# Equalizer Optimization for TDECQ

Version 1.1c

IEEE 802.3dj May Meeting

Comments Addressed: I-92, I-395, I-396

# Proposed Changes to p.479

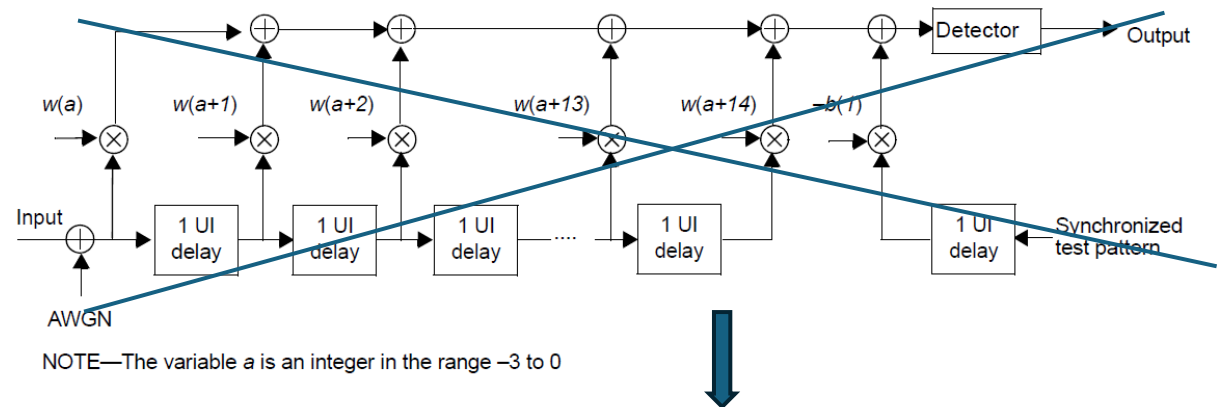
The reference equalizer is a T-spaced discrete-time equalizer with 15 feedforward taps and a single decision feedback tap, where T is the symbol period. Equalizer coefficient constraints are given in Table 180-16. The reference equalizer may be implemented in the oscilloscope. The decisions fed back in the equalizer are modeled as being correct, so the equalizer is modeled as shown in Figure 180-10, where  $x(n)$  is the  $n^{\text{th}}$  symbol in the test pattern sequence,  $r(t)$  is the output of the reference receiver defined in 180.9.2,  $\eta(t)$  is colored Gaussian noise,  $z(t) = r(t) + \eta(t)$ ,  $z_n = z(nT + \phi)$ , where  $0 \leq \phi < T$ , and  $y_n$  is the equalizer output corresponding to  $x(n)$ . The Bessel-Thomson (BT) filter shown is identical to that in 180.9.2. The received signal  $r(t)$  is aligned with the test pattern such that  $r(nT)$  corresponds to  $x(n)$ .

## 180.9.6.3 Reference equalizer

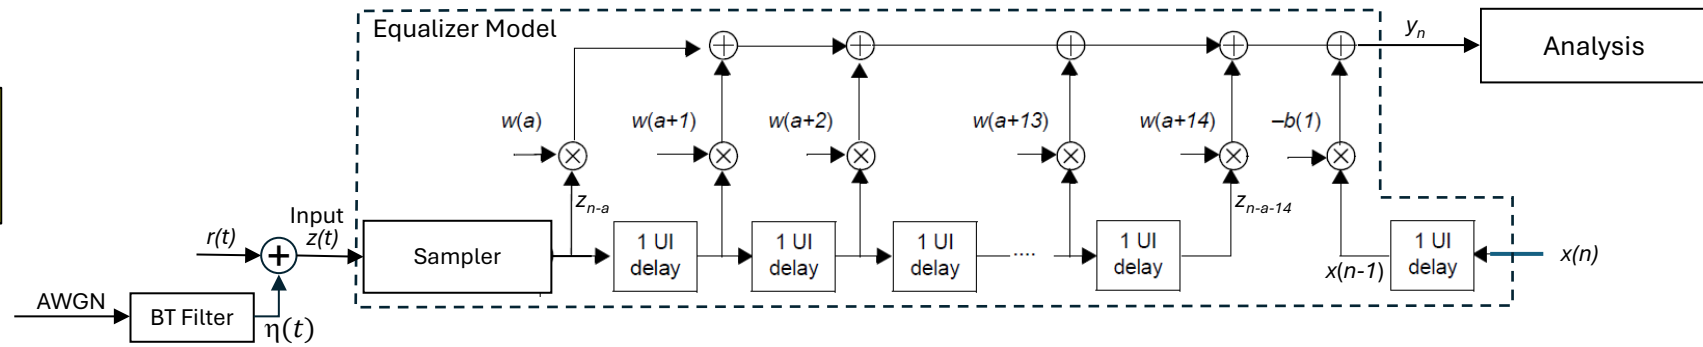
NOTE—The variable a is an integer in the range -3 to 0
